California High-Speed Train Project

**RFP No.: HSR 11-16
Design Variance Report**

FRESNO STATION CROSSOVER DISTANCE FROM STATION
HST TRACK ALIGNMENT SPIRAL/VERTICAL CURVE OVERLAP
OCS CLEARANCE ASHLAN AVE
OCS CLEARANCE UNDER FUTURE RECONSTRUCTED FRESNO YARD OVERHEAD

DESIGN VARIANCE COVER SHEET

PROFILE

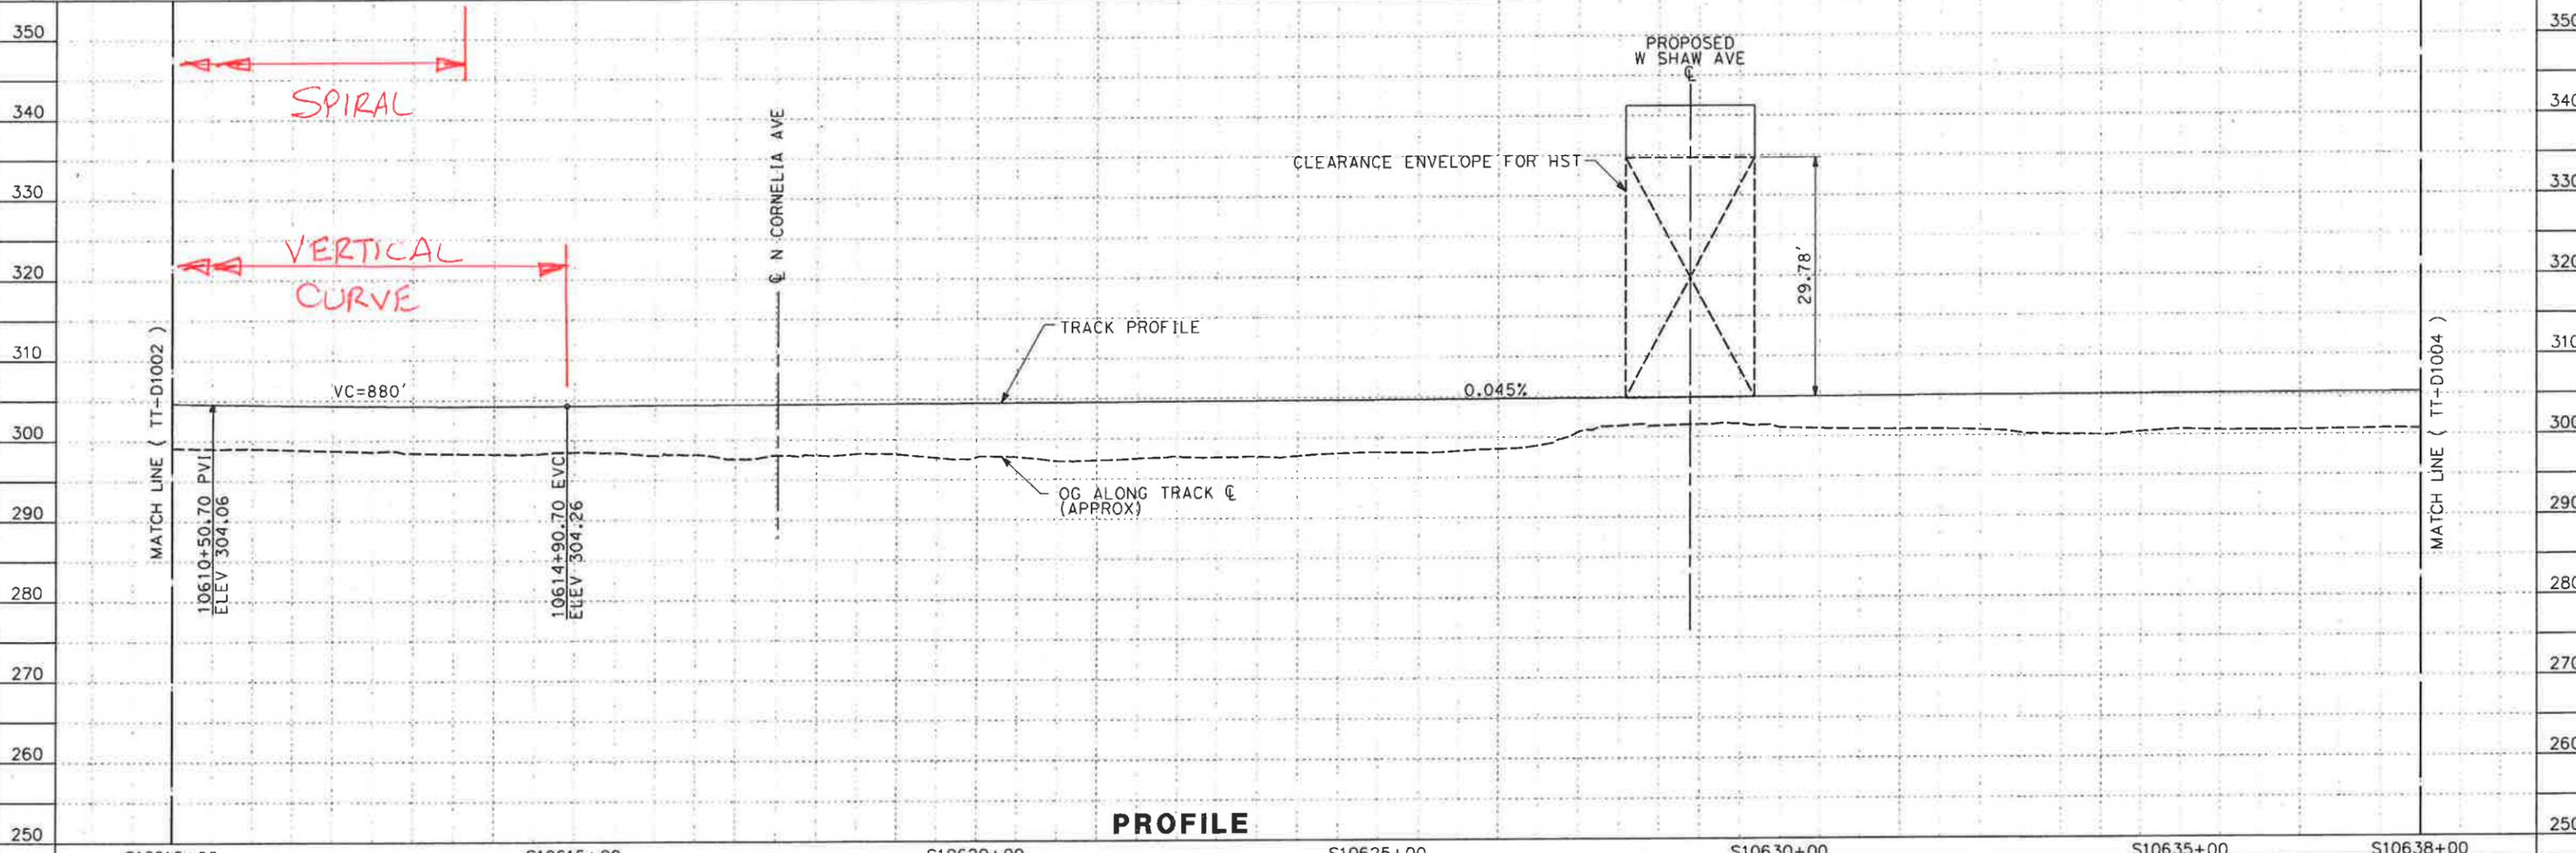
CHSTP DESIGN REQUIREMENT Include reference to drawings, design criteria, technical memos, specifications	TM 2.1.2 Section 6.1.7
DESIGN CRITERIA REQUIRING A VARIANCE	No overlap allowed between spiral curves and vertical curves for HST track alignment.
REASON FOR REQUESTING VARIANCE	To keep the top of rail profile as close to existing ground as possible thus avoiding the need for embankment fill or retaining walls.
JUSTIFICATION FOR VARIANCE	To avoid unneeded additional capital cost to the project.
PROPOSED ALTERNATIVE DESIGN REQUIREMENT	Allow overlap of vertical curves with spiral curves.

OPERATIONS	N/A
MAINTENANCE	Possible slight increase in maintenance costs due to complexity of HST track alignment.
INFRASTRUCTURE	<p>General The HST alignment must pass underneath a proposed roadway overcrossing at Veterans Blvd. (station S10535+81) and a new roadway overcrossing at Shaw Ave. (station S10628+87). Between these locations the HST alignment will cross Herndon Canal on a new bridge at station 10592+66.</p> <p>The top of rail profile is designed to pass under the two roadway overcrossings and must rise to provide sufficient structure depth for the Herndon Canal bridge while maintaining proper freeboard over the water surface.</p> <p>There are three locations where the spiral/vertical curve overlaps. Location 1 is the vertical curve at station S10548+36 which overlaps the spiral on curve #101. Location 2 is the vertical curve at station S10592+66 which overlaps the spiral on curve #102. Location 3 is the vertical curve at station S10610+51 which overlaps the spiral on curve #102.</p> <p>Reason Moving the two vertical curves identified above will result in a raised the top of rail profile between the proposed vertical curve PVI locations, a distance of approximately 4,430 feet. The top of rail would be approximately 8 feet higher along this section.</p> <p>This raised profile will require additional embankment fill along the 4,430 feet to accommodate the raised track profile.</p> <p>Other Options Another option would be to introduce additional</p>

vertical curves within this area of the alignment however this will result in a "roller coaster" type of effect for HST patrons. Justification The raised top of rail profile will require additional embankment fill, thus adding cost to the project. The increased embankment would eliminate the opportunity for open drainage ditches thus requiring a closed drainage system.
RAILROAD SYSTEMS	N/A
RELIABILITY / FUNCTIONALITY	N/A
THIRD PARTY (Utility, Freight, Caltrans, RR, other)	N/A
SAFETY AND SECURITY	N/A
DIRECT COST	No detailed cost estimate. The increased cost of the embankment and inclusion of a closed drainage system would alone will be in excess of \$500,000.
OTHER	Possible increased maintenance cost of drainage system.

CALIFORNIA HIGH-SPEED TRAIN PROJECT
MERCED TO FRESNO
 PACKAGE 1A
 ROADWAY
 ASHLAN OVERHEAD
 GENERAL PLAN

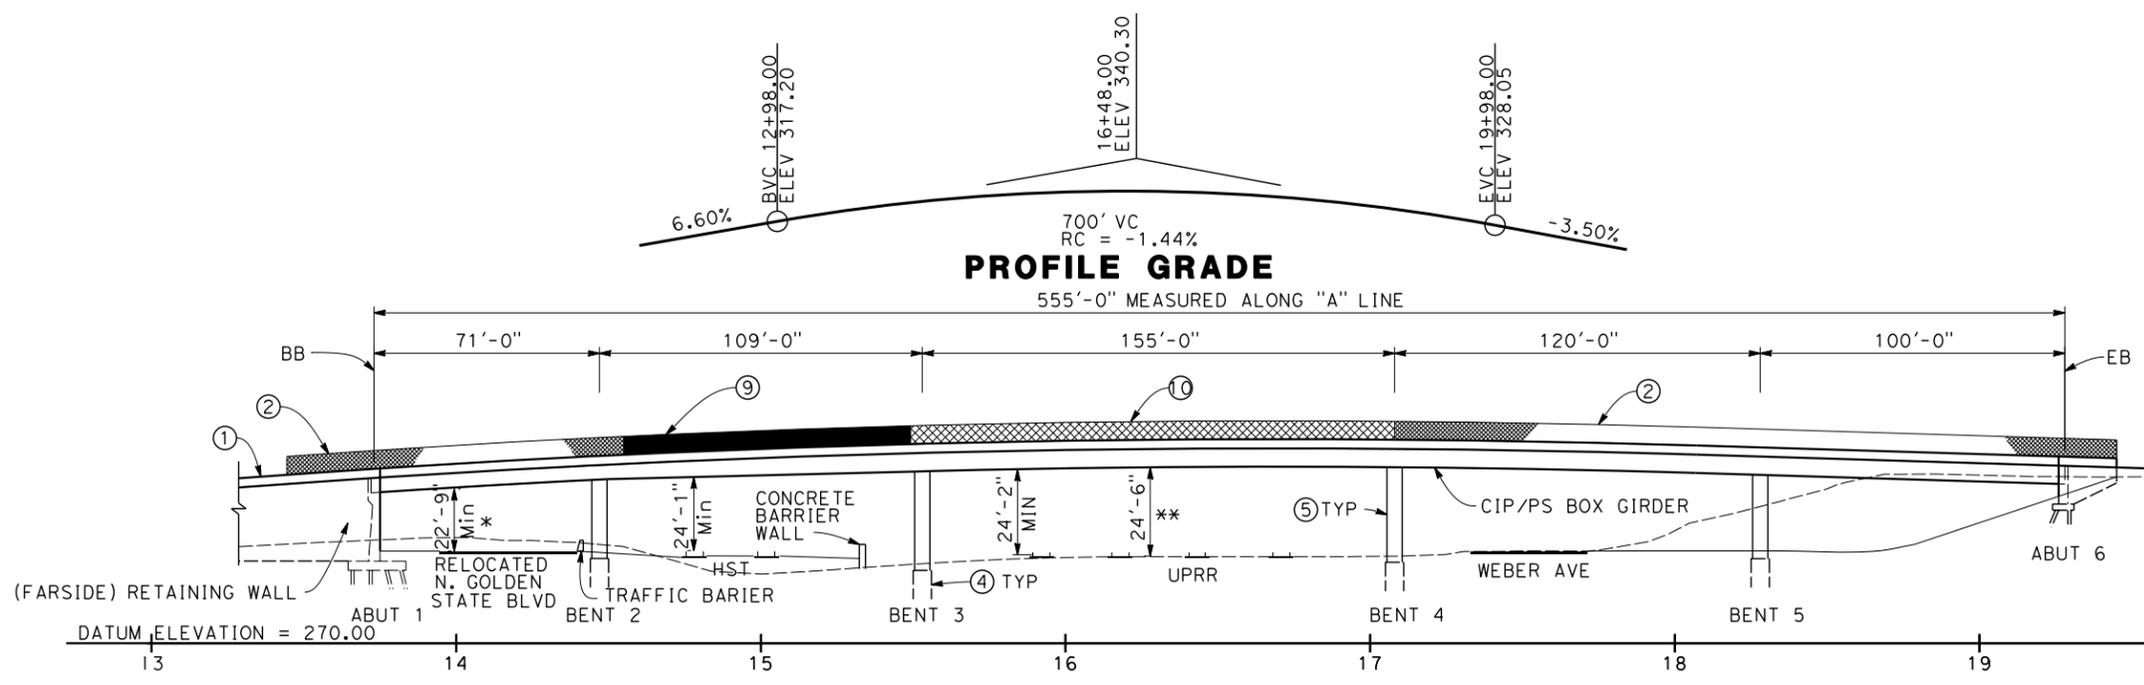
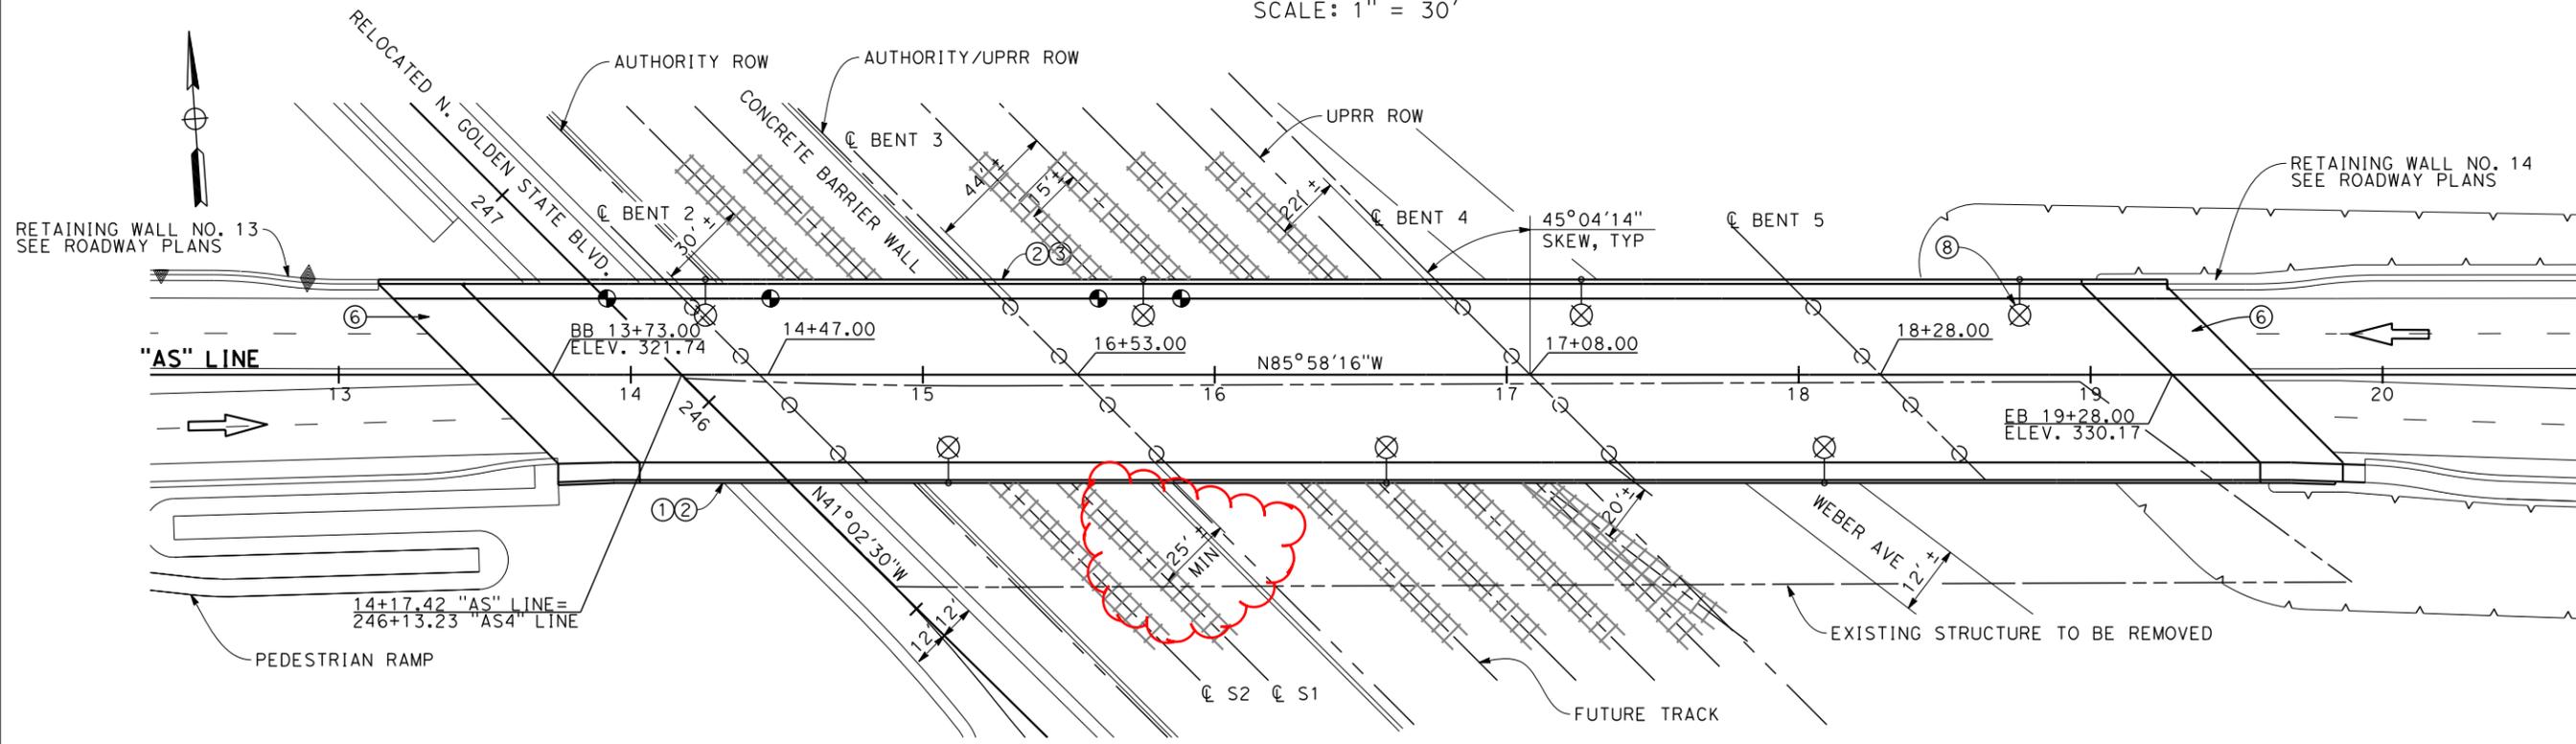
CHSTP DESIGN REQUIREMENT Include reference to drawings, design criteria, technical memos, specifications	TM3.2.1 – OCS requirements, Track work Flood elevation clearance
DESIGN CRITERIA REQUIRING A VARIANCE	The vertical clearance of 27 ft for installation of OCS system under new or planned over-crossing structure TOR 2.5 ft above flood elevation
REASON FOR REQUESTING VARIANCE	Any rise of profile of the new structure relative to the existing structure it replaces results in higher project impact, mitigation, delays and cost. Lowering HST will result in track work below estimated flood elevation, which may require boat-section and pump station To eliminate the requirement to lower the track work below the estimated flood elevation a variance to reduce the vertical bridge clearance to 22ft would be required
JUSTIFICATION FOR VARIANCE	To minimize the dip in the alignment under Ashlan Ave, maintain track elevation above existing ground and 2.5ft above estimated flood elevation. Achieves best possible vertical track alignment with minimum grade change, eliminates need for boat section and pumping equipment/maintenance. Provides the best track alignment profile for the least cost

PROPOSED ALTERNATIVE DESIGN REQUIREMENT	Allow minimum clearance under replacement bridge to be 22 to 24ft , this equates to TM 3.2.1 Directive Drawing for existing bridges up to 120 ft wide with free running OCS and reduced System Depth. Use Up to 2 ft of Walls/boat section for flood protection Or Allow deeper track work construction below flood elevation, while protected by a boat-section and pump station may be needed

Exhibit 8

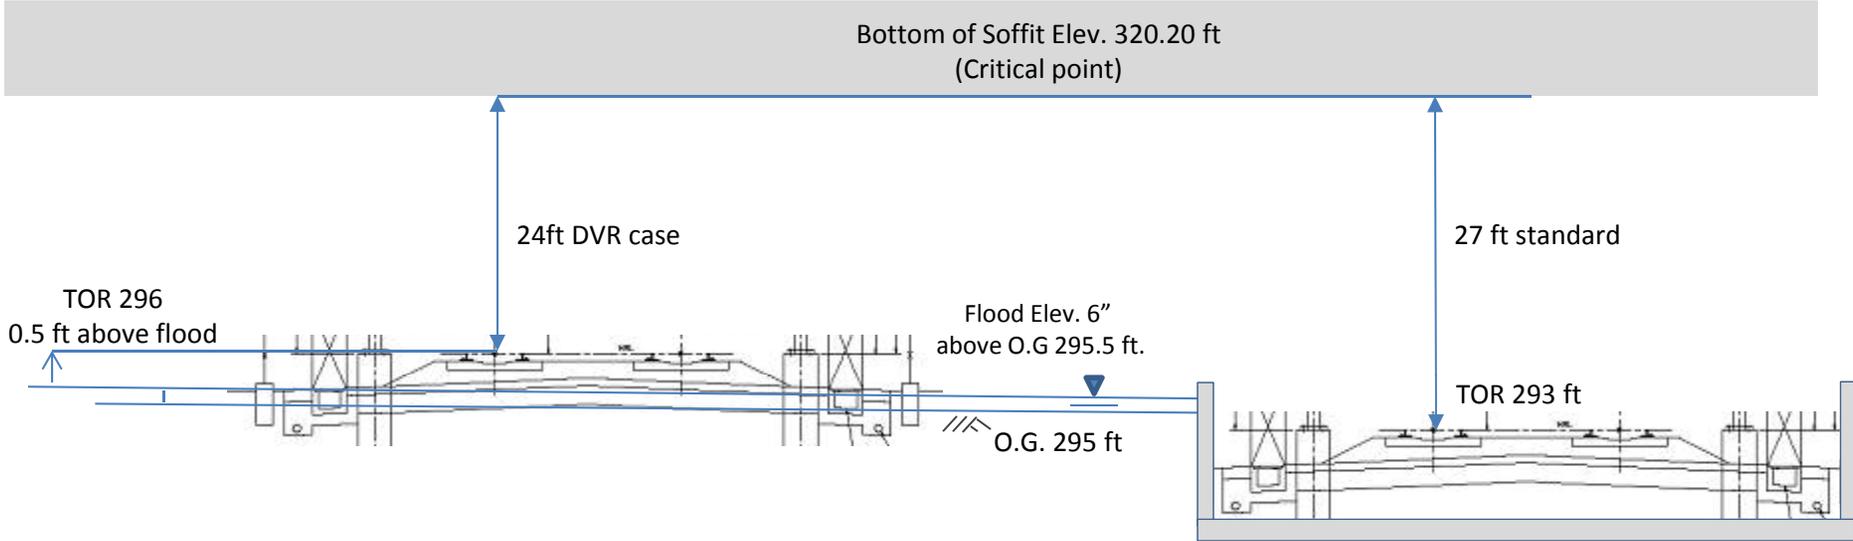
ASHLAN BLVD					
Structure Depth =	5.14'	(@ SB Track)			
Structure Depth =	5.46'	(@ NB Track)			
Clearance Check Locations:	STA ("AS")	CL ELEV	Offset	EP ELEV	Soffit ELEV
A - NB Track	14+81.17	326.87	32.50	326.22	320.76
B - NB Track	15+50.80	329.27	37.00	328.53	323.07
C - SB Track	14+57.81	325.90	32.50	325.25	320.11
D - SB Track	15+27.45	328.54	37.00	327.80	322.66
Clearance Check Locations:	STA ("S1" or "S:TOR ELEV	Vert Clr (Soffit - TOR)			
A - NB Track	10700+32.73	296.00	24.76		
B - NB Track	10701+31.12	296.01	27.06		
C - SB Track	10700+16.20	296.00	24.11 Min		
D - SB Track	10701+14.59	296.00	26.66

24 ft Min Vertical Clearance (Recommended)
